**April 25, 2017**

**ADDENDUM NO. 1**

**Durham County Courthouse Security System  
RFP 17-031**

**Durham County Courthouse Floor Plans**

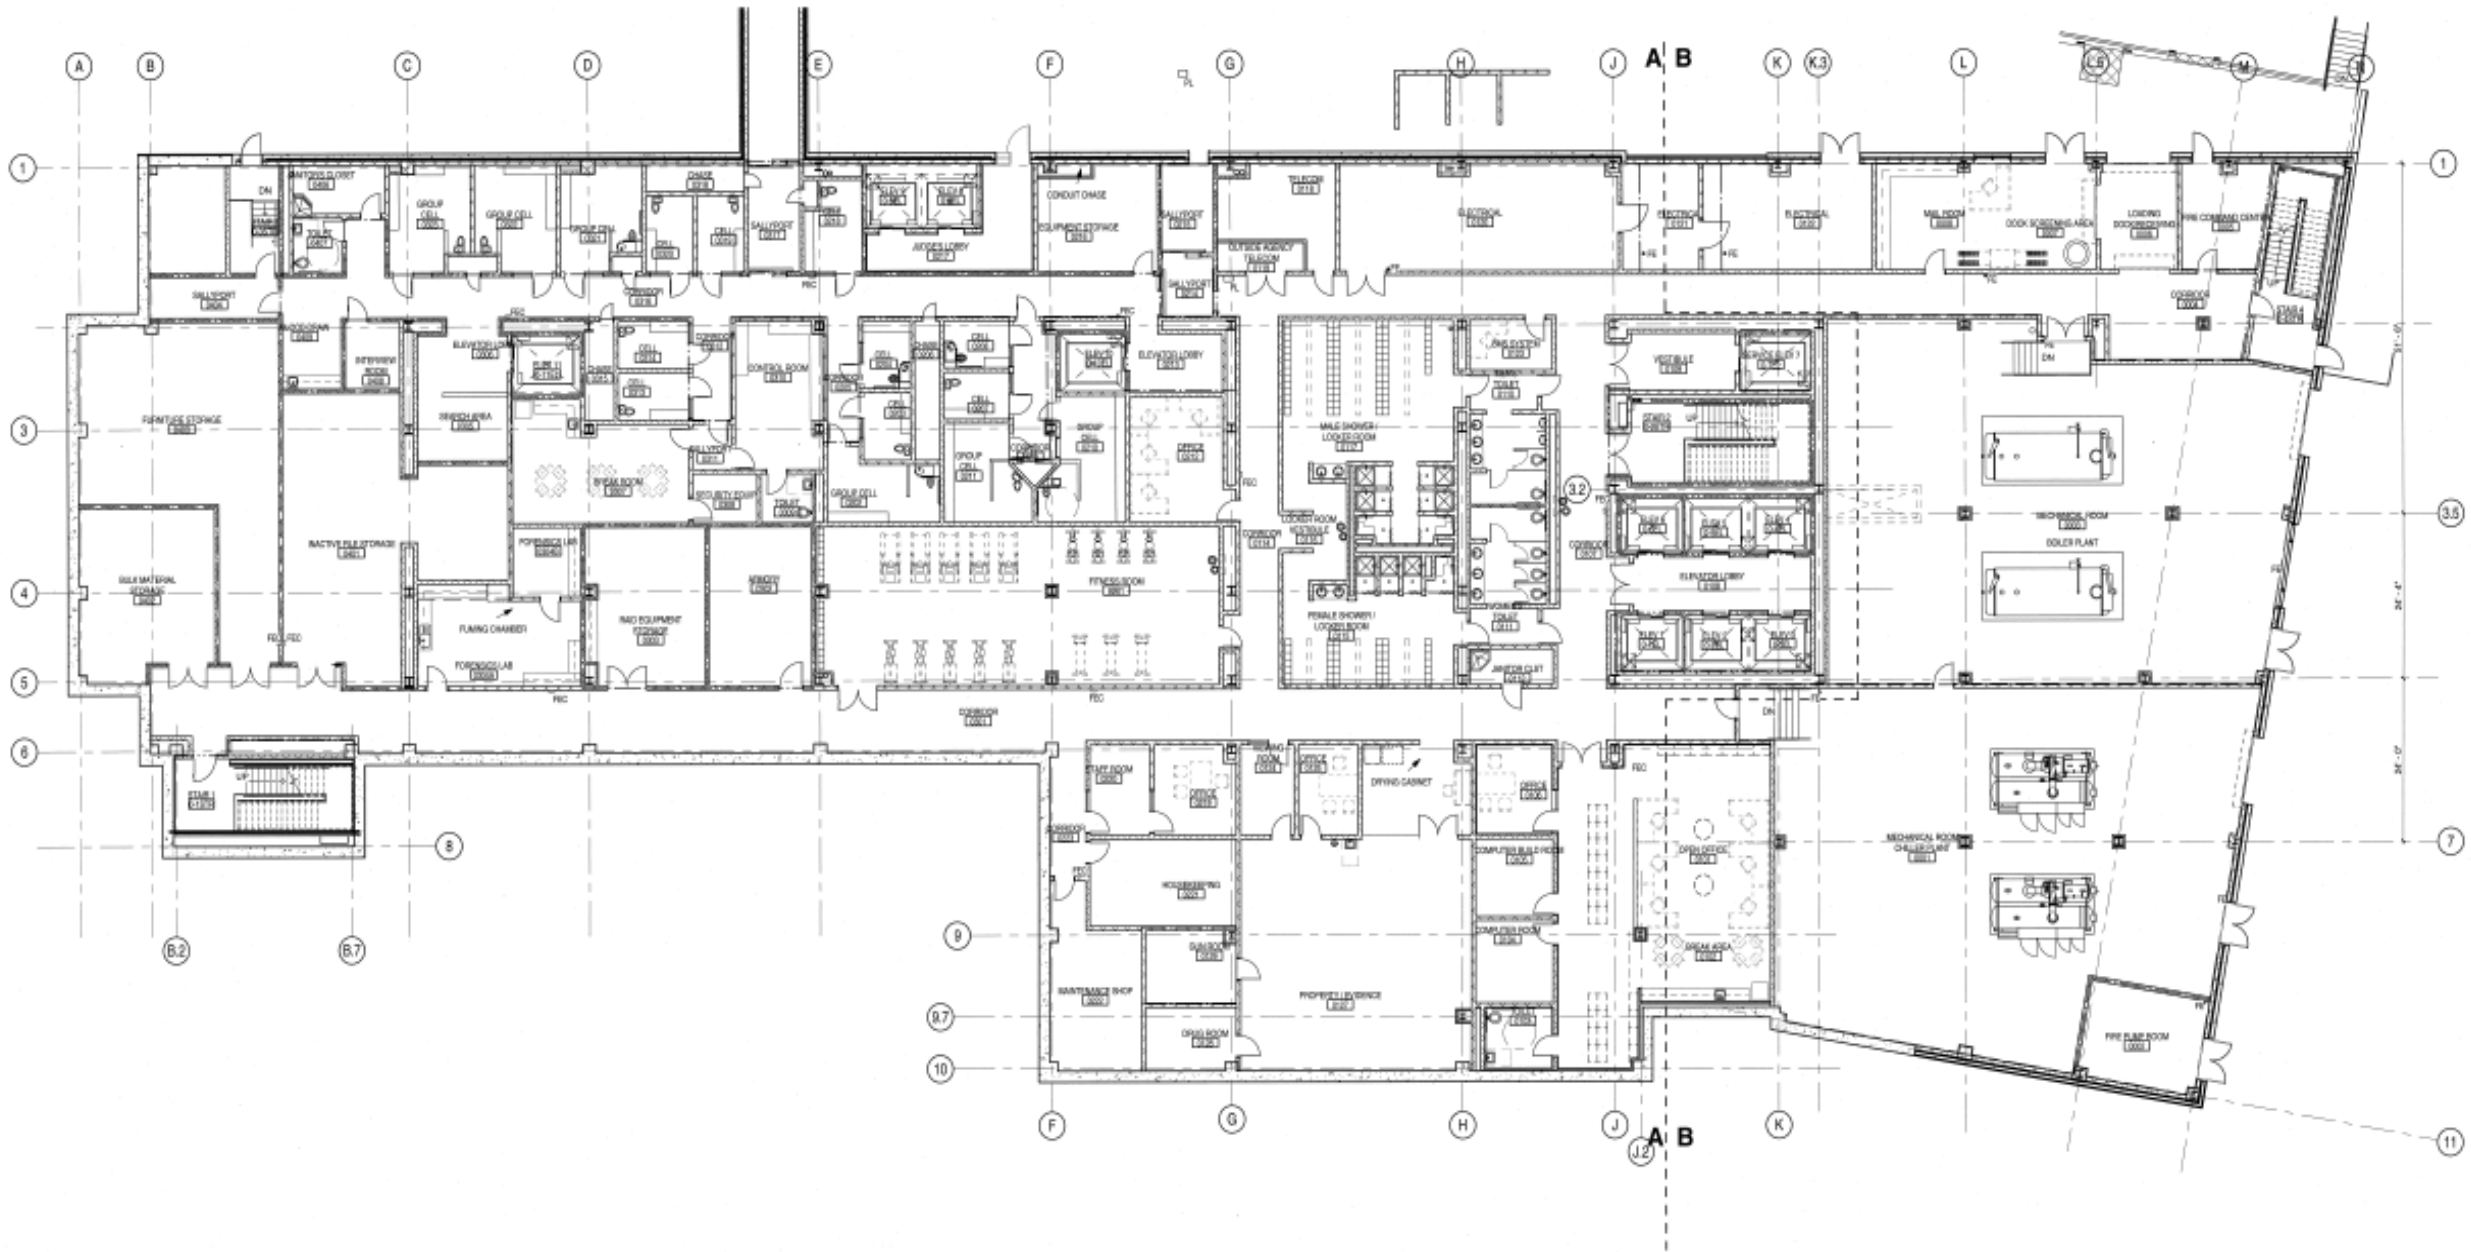
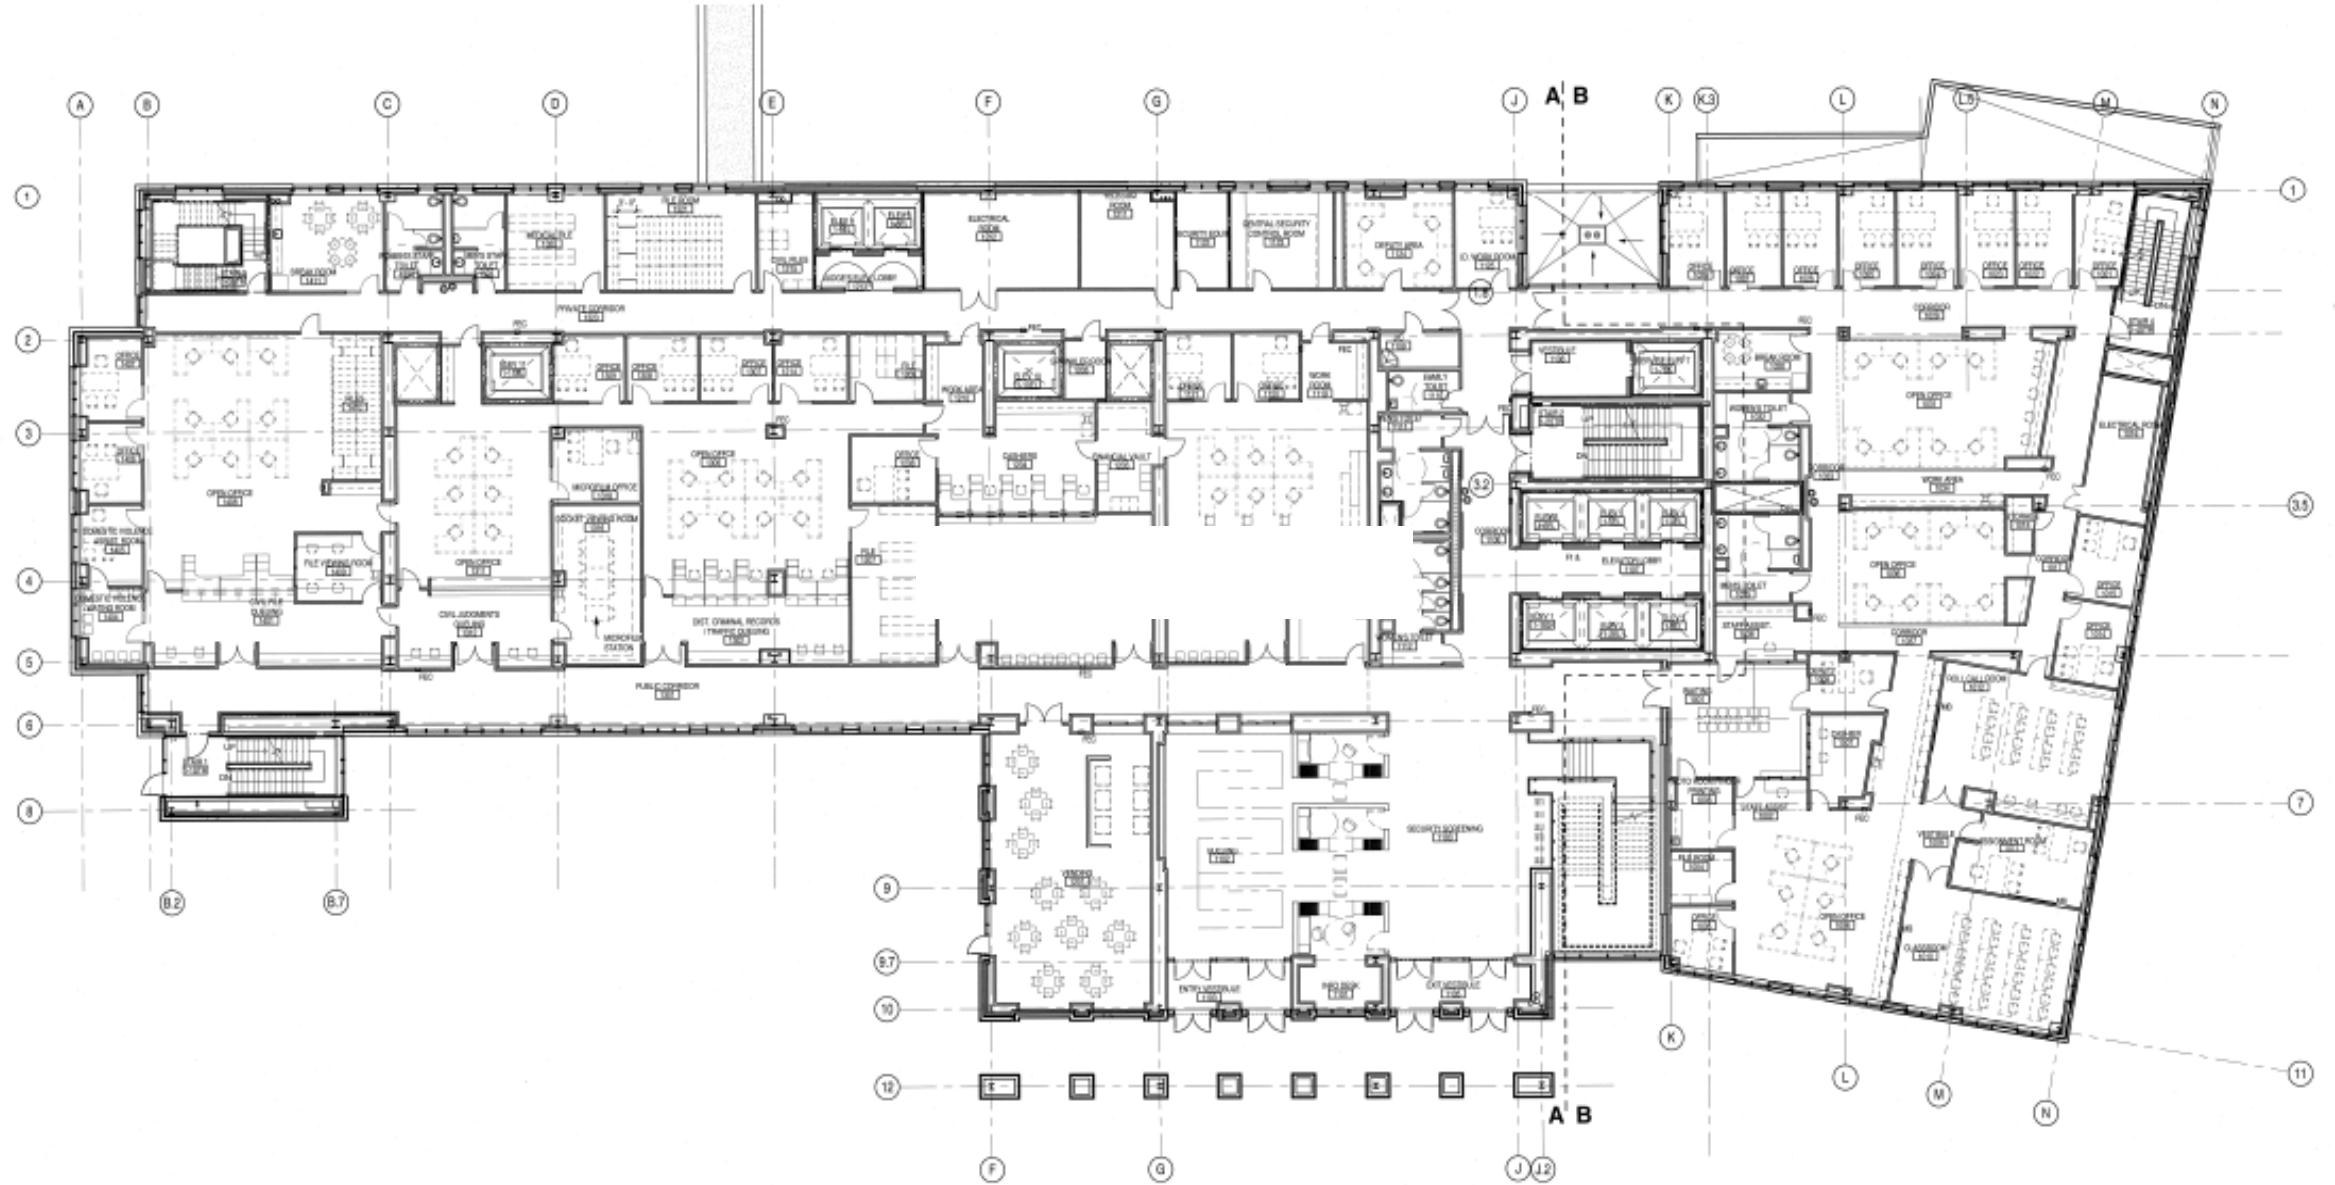
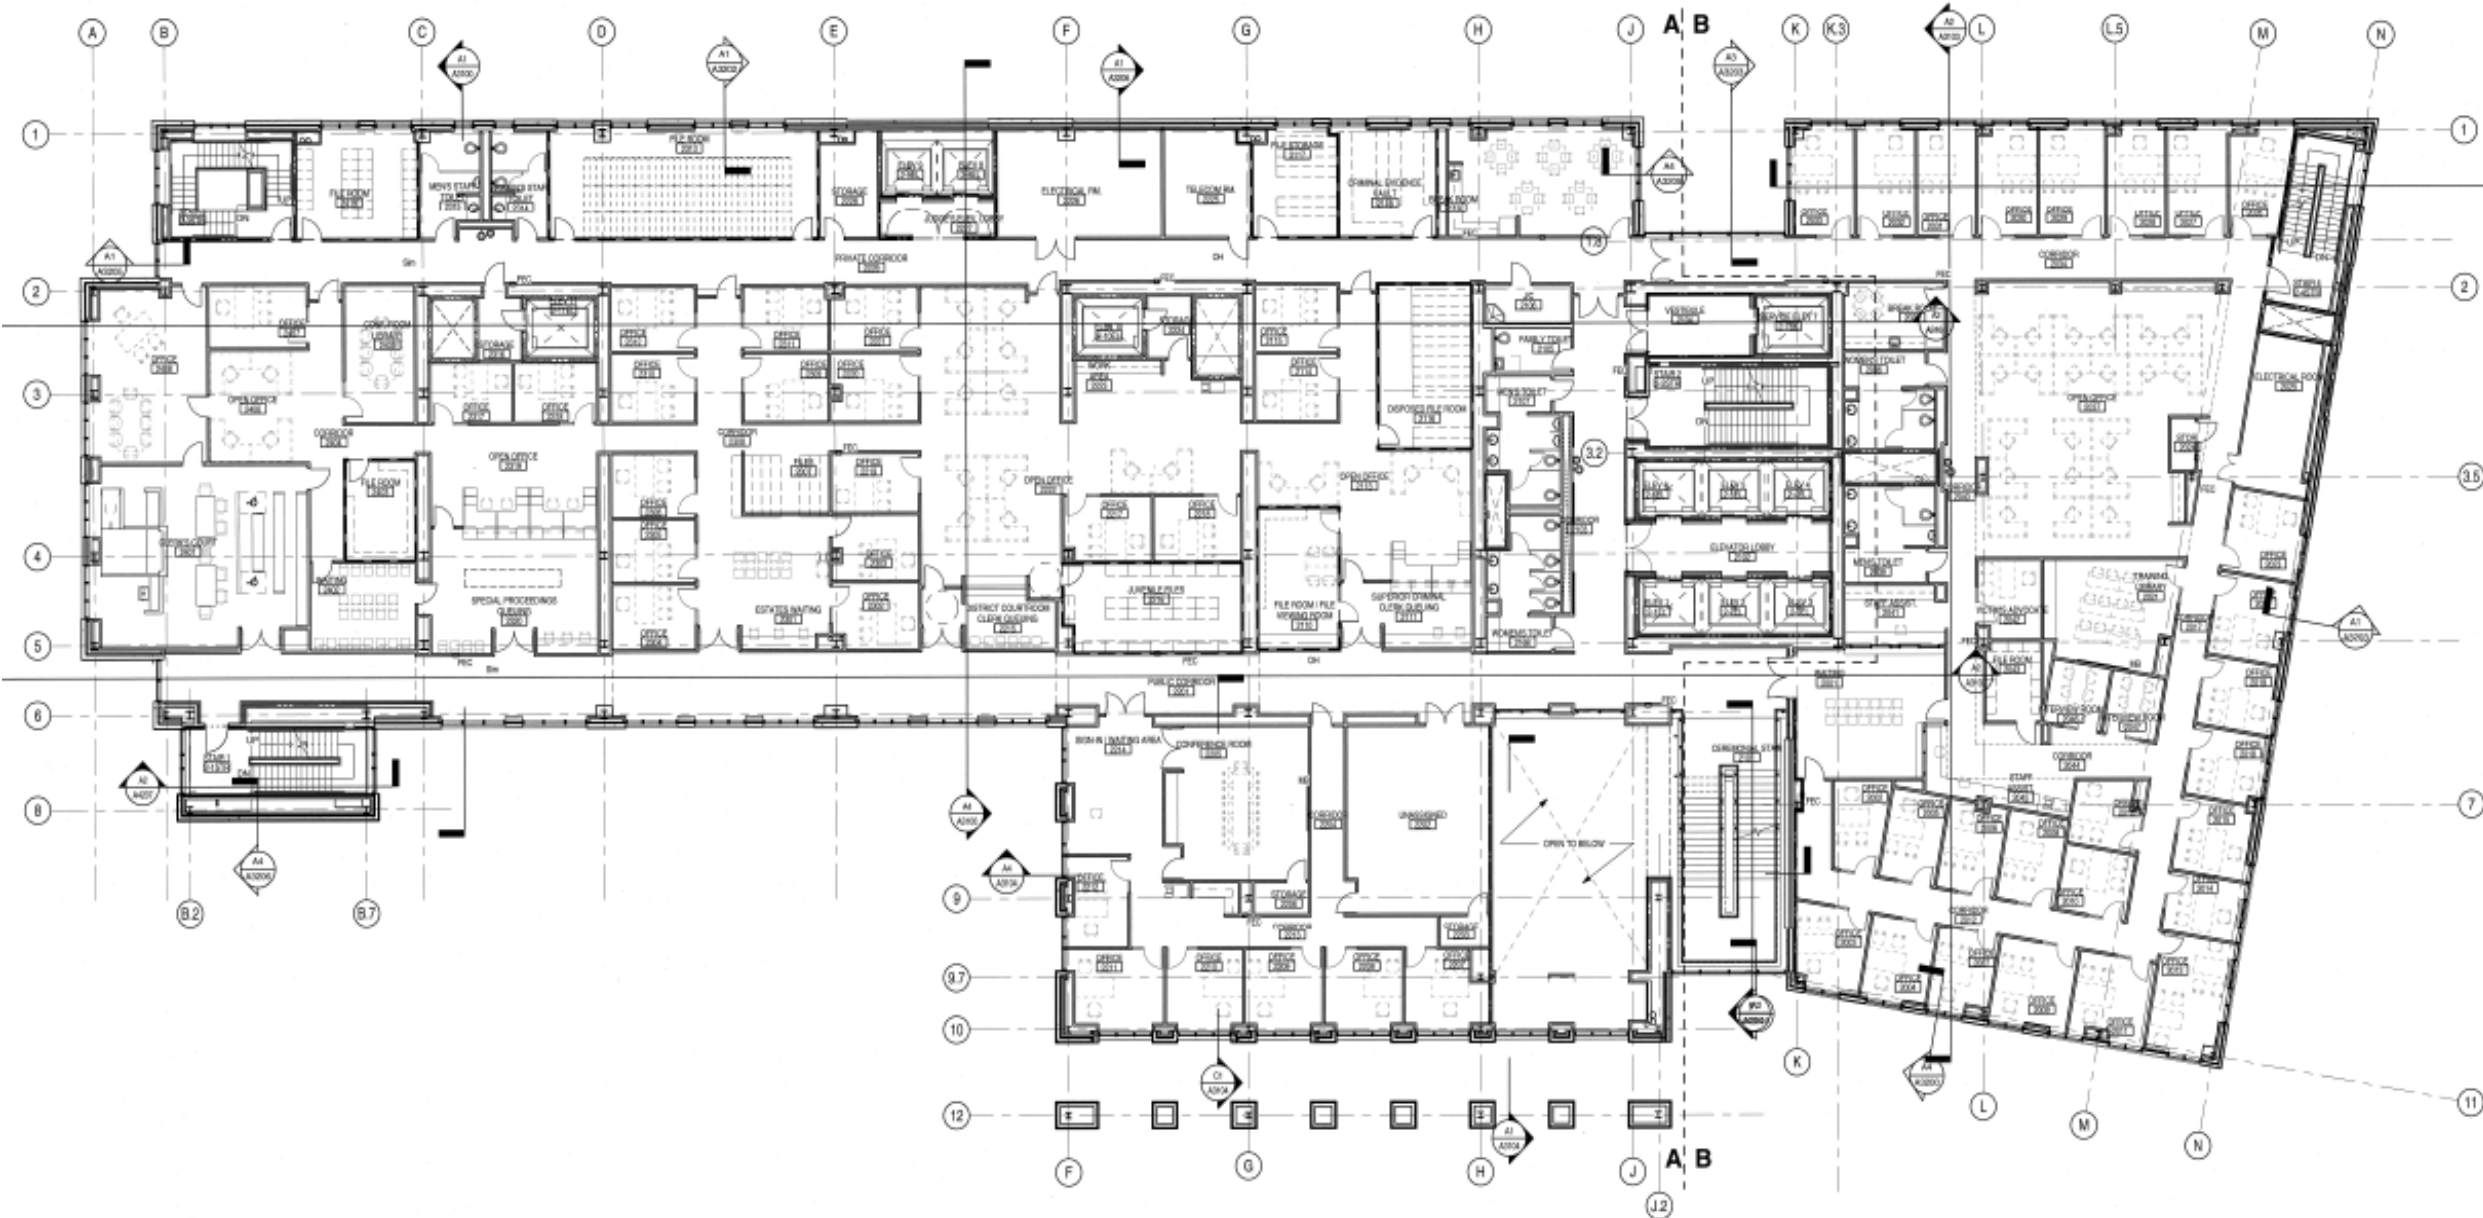
**Question 9** Are Maps required? If so, will CAD files be provided? Or will appropriate MAP files be provided?

**Question 27** Please provide a set of the PDF maps that are to be used in the system. This is to allow for estimating the amount of time to prepare the plans for importing into S2.

**Response** See Attachment 3 Durham County Courthouse Floor Plans

**Response** See Attachment 3, Durham County Courthouse Floor Plans
